PERMIT NO.
23287

CITY OF NEW BEDFORD
SEWER AND/OR STORM DRAIN PERMIT

to connect a sewer and/or storm drain located at Brantwood St. # 936 (S.S.)
Assessor's Plot 137A, Lot 296 & 297, to the sewer and/or storm drain in Brantwood St.
to be laid in accordance with the conditions in this application and the City of New Bedford ordinances.

INSPECTOR'S REPORT

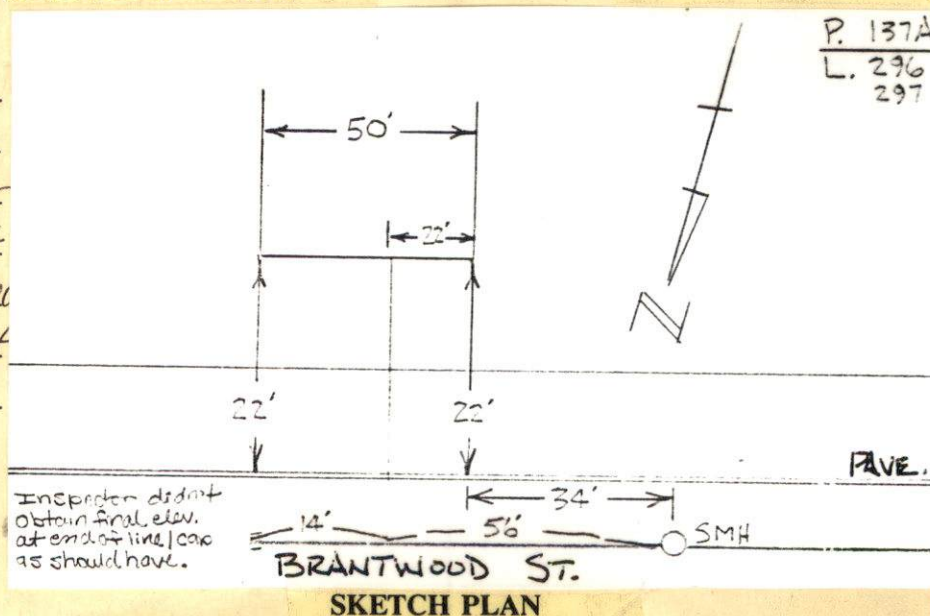
COMMENTS: No notes from inspector
as to final elevation of line at point
where capped - was to have field checked
per attached sketch and this permit

SKETCH PLAN

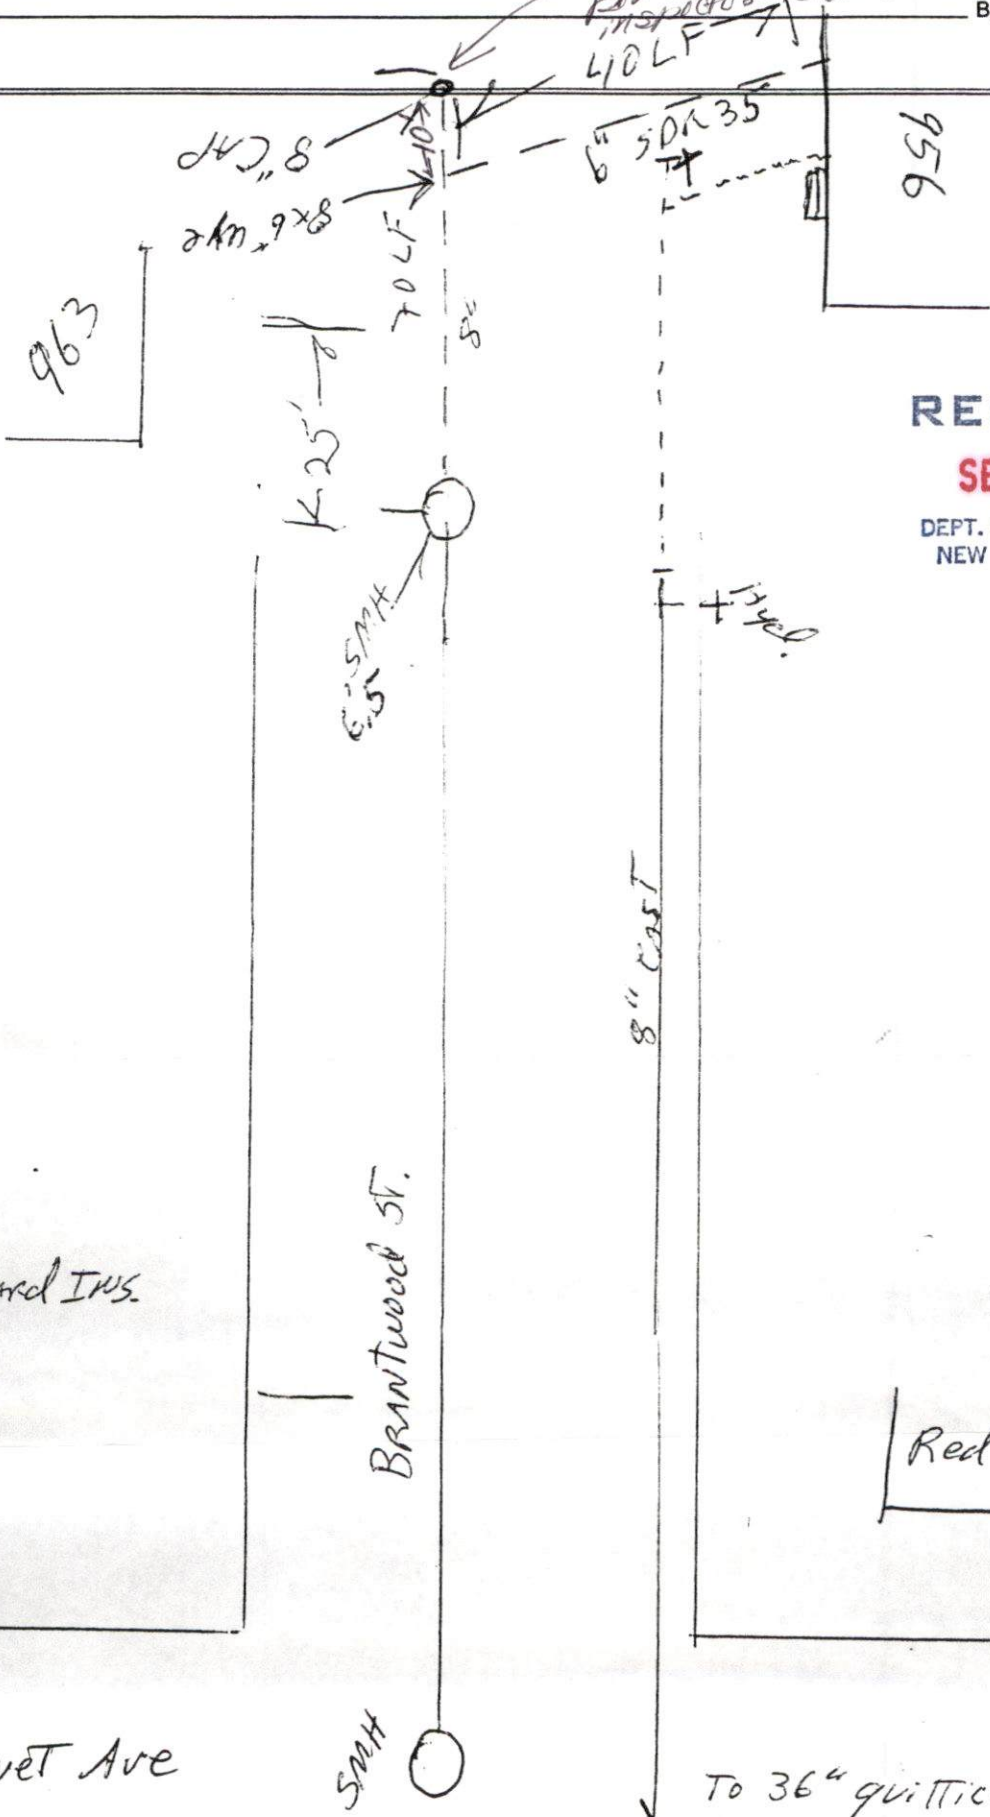
Upland St. 40' (6" SDR 35) for service to house w/ 8" x 6" wye; 8" cap at end
of 8" sewer main. Per Duarte Andrade, terminal point of 70' 8" line not to be less
than 6' final ☒ Sewer elevation to be provided by sewer inspector upon inspection - Sketch o.k. as is.

no more to 100' 6"
for final elevation at mil
for Duane Andrade 9/19/02 - sewer
for 100' 0" to ok final elevation.
410 LF
